**CITY OF FOREST PARK**  
**URBAN DESIGN REVIEW BOARD MEETING**

Friday, July 18, 2025, at 12:00 PM  
Council Chambers

# URBAN DESIGN REVIEW BOARD

## STAFF REPORT

## LANDSCAPE BUFFER

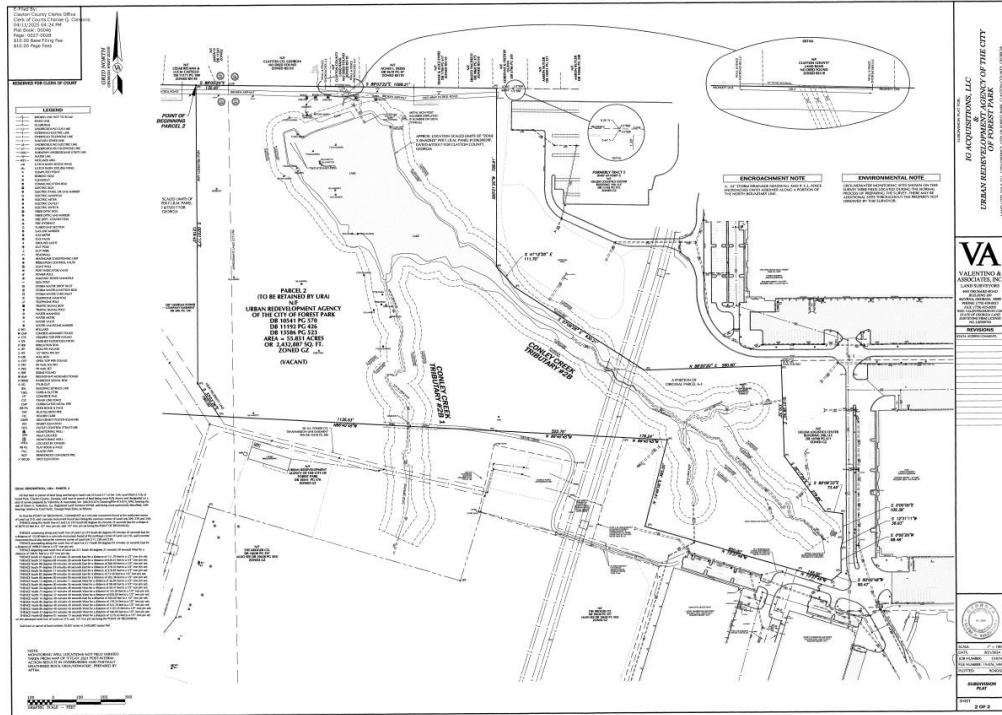
4. An 8-foot obscuring wall shall be installed along the north and west sides of the site. An "obscuring wall" refers to a masonry structure made of brick, stone, or similar materials, designed to block views and reduce sound transmission.

5. A 15-foot-wide buffer zone shall be planted with vegetation at least eight feet in height to provide a visual screen. All landscaping must be irrigated and properly maintained.

## BUILDING 1 ELEVATIONS

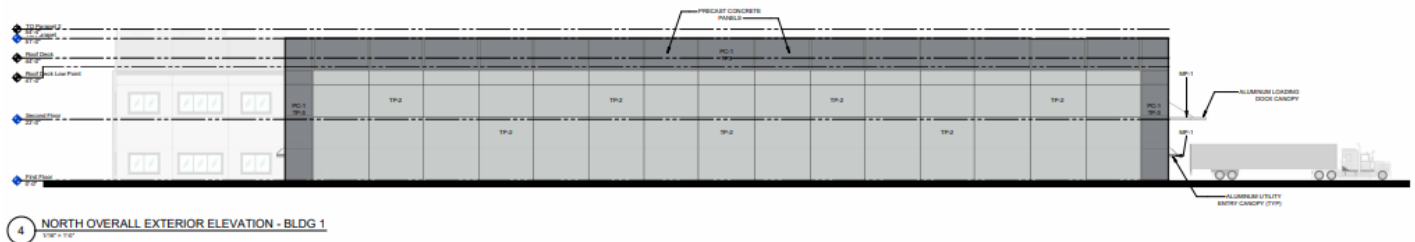
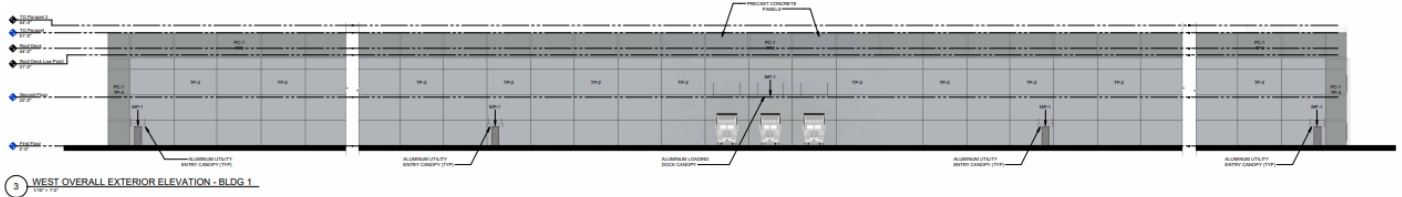
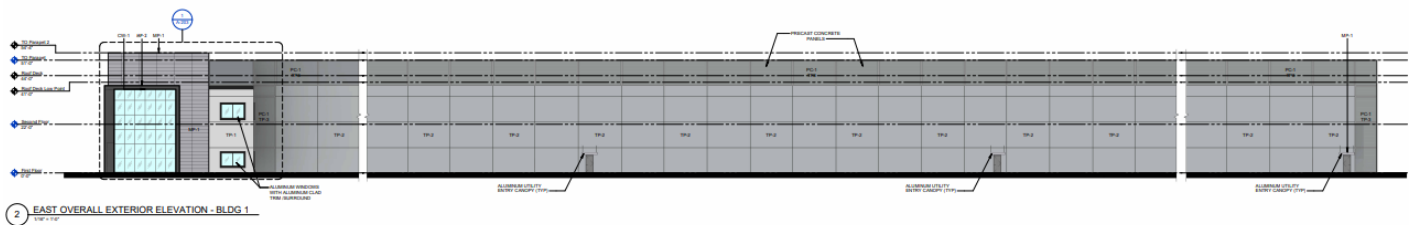
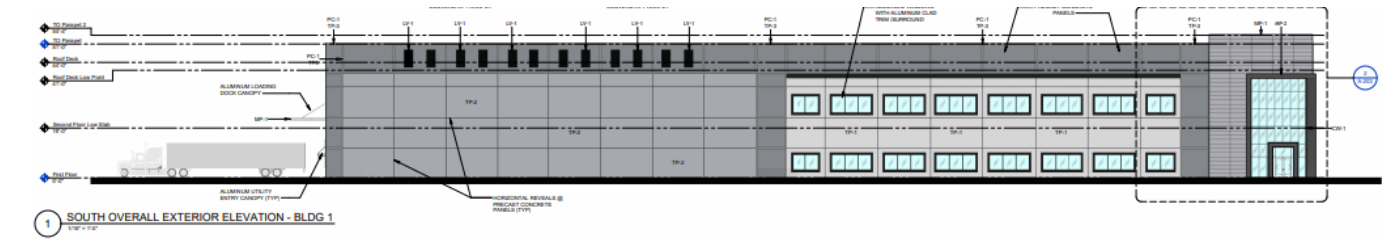
1. The side of the building facing the residential properties shall feature an enhanced façade incorporating thoughtful design elements and a mix of materials to improve visual interest and better integrate with the neighboring homes, given its close proximity.

2. The exterior walls must be soundproofed using a double-wall system, resilient clips, and a Green Glue noise control system.
3. All existing trees along the north and west perimeters of the property must be preserved.
